**COMMISSION OF ARCHITECTURAL REVIEW
STAFF REPORT
September 27, 2016 Meeting**

17. **CAR No. 16-129** (J. Farrar)

**2107 Cedar Street
Union Hill Old and Historic District**

Project Description: **Rehabilitate an existing home to include new windows, doors, siding, and roof; removal of the existing single story addition; and construction of a two story addition and deck at the rear.**

1905 Sanborn Map

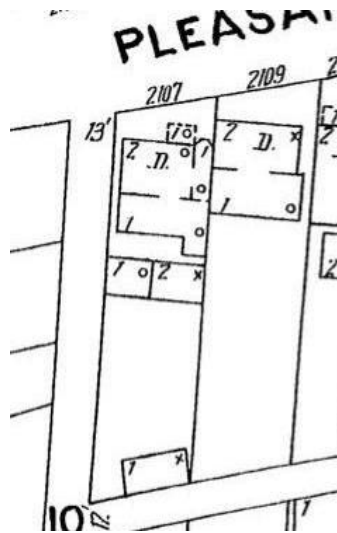
The Guidelines for Rehabilitation note that original features should be maintained and when replacing elements, the replacement should match the original in materials and design. Staff has concerns with the demolition of the single story projecting bay. Though the bay appears to be in poor condition, the structure was in place as of 1905, as seen in the Sanborn map, and staff believes it has obtained historic significance in its own right even if it may have not been originally present on the building in 1861. For this reason, staff recommends this element be retained.
